Docket Item # 1
BAR CASE # 2014-0298

BAR Meeting
October 1, 2014

ISSUE: Alterations

LOCATION: 218 North Columbus Street

PROPOSED
ATTACHMENT #1

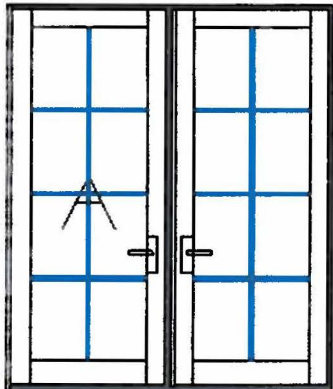
The applicant is requesting approval of a Certificate of Appropriateness to convert two existing single doors with segmental arches on the south elevation of the front unit to a pair of French doors. The alterations include removing an existing brick mullion between the two single openings. The proposed pair of French doors will be aluminum-clad, eight-light doors with a flat lintel. The work will be done as part of a repointing project to address other cracking and settlement issues.

The area proposed for alteration is on a secondary elevation and is presently located behind a 6+ foot tall wood fence, making only the top portion of the area visible from a public way. In addition, the area proposed for alteration has already been subject to alterations as part of the 1977 townhouse conversion which created exterior access doors on the north and south elevations for the individual units.

The *Design Guidelines* state that “exterior doors and surrounding details should be appropriate to the period of the structure.” A site visit revealed that several historic window openings were bricked in as part of the earlier renovation and newer ground-floor openings were created. Staff finds the proposed use of a simple flat brick lintel to be appropriate for this 19th-century building. As this building has already been altered as part of the adaptive reuse, and the proposed alteration is on a secondary elevation, staff has no objection to the requested change. The applicant has proposed aluminum clad French doors and due to the location on the side and behind a fenced courtyard, staff can support this material in this location.

Staff recommends approval of the Certificate of Appropriateness, as submitted.
